# SAFETY RECALL

# SR16-86E

THIS REVISION SUPERSEDES PREVIOUS VERSION

## 12-VOLT POWER SOURCE RELAY REPLACEMENT 9700 (B13R)

FIGURE 1: WIRING DIAGRAM SHOWING K918 & K919 – EQUIPPED WITH ALLISON TRANSMISSION

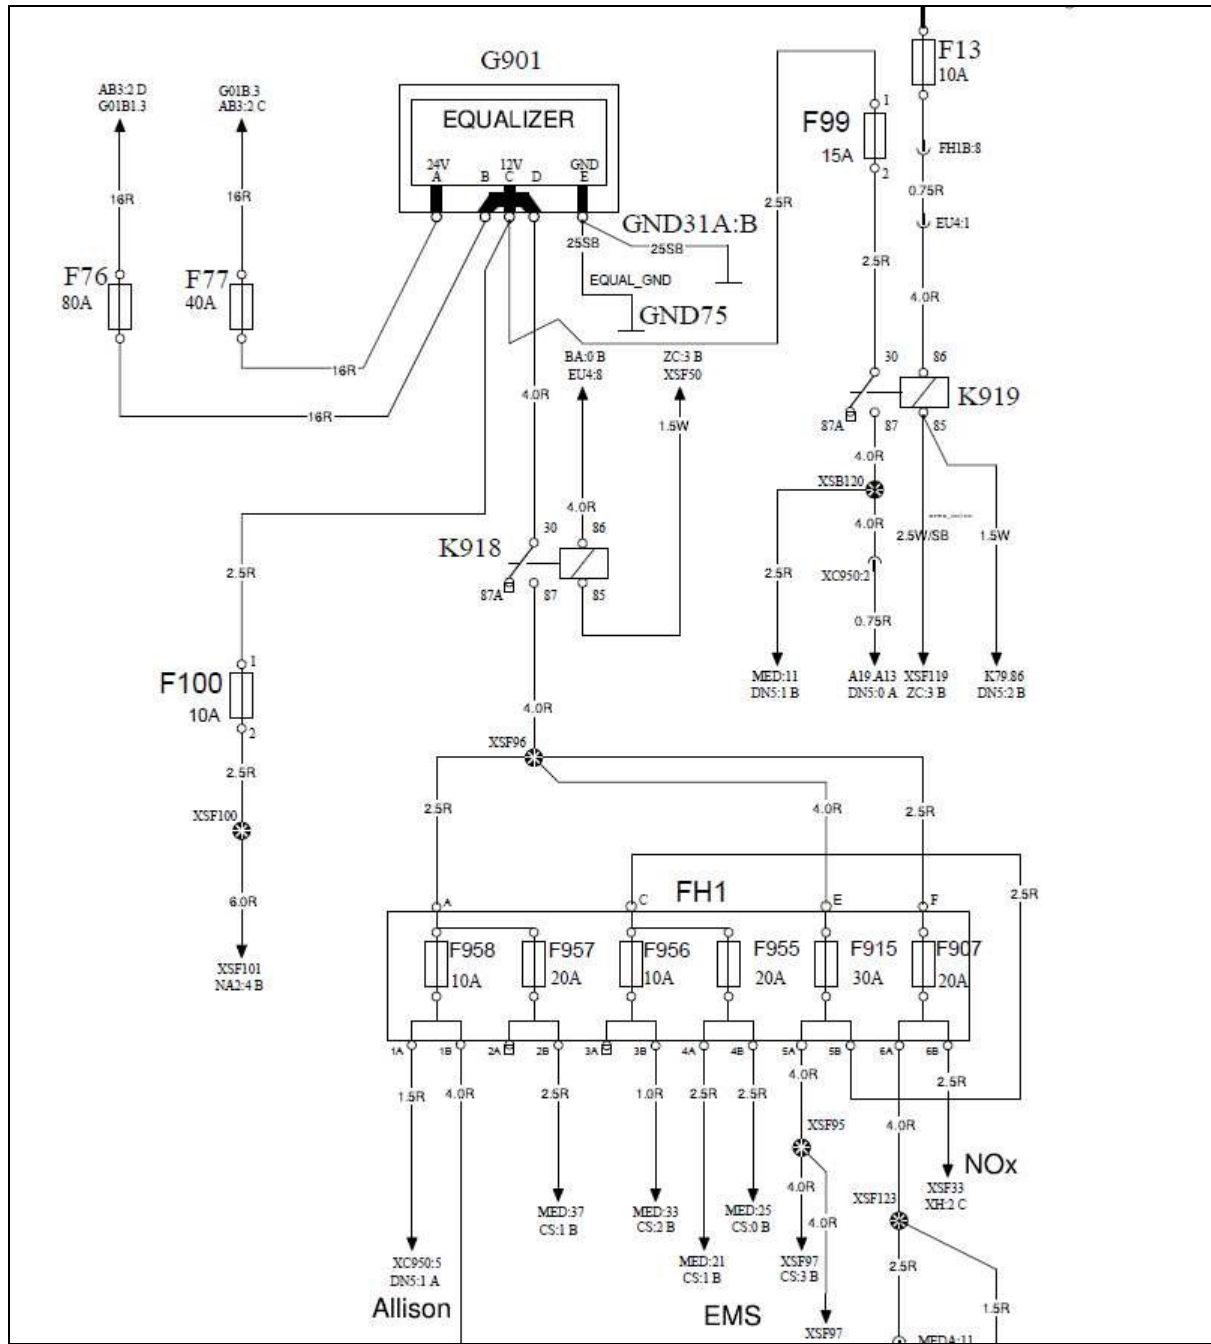
RANGE	WHAT TO DO
Model Year: up to 2013 Vehicles up to 3CET2S22XD5 <u>160297</u>	<b>Relay K917:</b> Replace existing relay K917 with relay p/n 21244697 (Cartier <b>Mini</b> ) <b>Relay K918:</b> Replace existing relay K918 with relay p/n 564218 (Cartier <b>Maxi</b> ). Refer to the following instruction.
Model Year: 2013 – 2015 From 3CET2S225D5 <u>160756</u> up to 3CET2V227F5 <u>168569</u>	<b>Relay K918:</b> Replace existing relay K918 with relay p/n 564218 (Cartier <b>Maxi</b> ). Refer to the following instruction.
Model Year: from 2015 Equipped with <b>Allison transmission</b> From 3CET2V224F5 <u>169811</u>	<b>Relay K919:</b> Replace existing relay K919 with relay p/n 21244697 (Cartier <b>Mini</b> ) <b>Relay K918:</b> Replace existing relay K918 with relay p/n 564218 (Cartier <b>Maxi</b> ). Refer to the following instruction.
Model Year: from 2015 Equipped with <b>I-Shift transmission</b> From 3CET2V224F5 <u>169811</u>	<b>Relay K918:</b> Replace existing relay K918 with relay p/n 564218 (Cartier <b>Maxi</b> ). Refer to the following instruction.

FIGURE 2: RELAY K919 LOCATED UNDER THE DRIVER AREA FLOOR

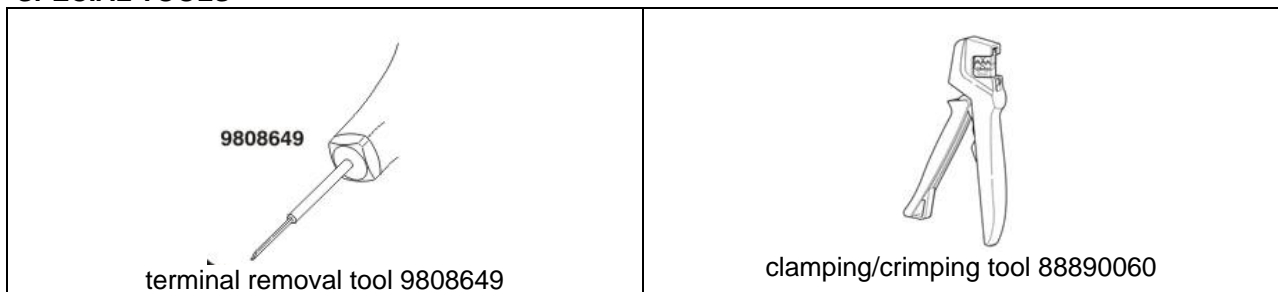
- 2) Identify the scenario applicable to the vehicle.
- 3) Locate the relays that are involved in accordance with the applicable scenario (one or two relays to be replaced).
- 4) Remove the existing relay and change it for a new relay in accordance with the scenario above. An easy adaptation is necessary when replacing relay K918. To do it, perform steps 5 up to 15.
- 5) Locate relay K918. See FIGURE 4 & FIGURE 5
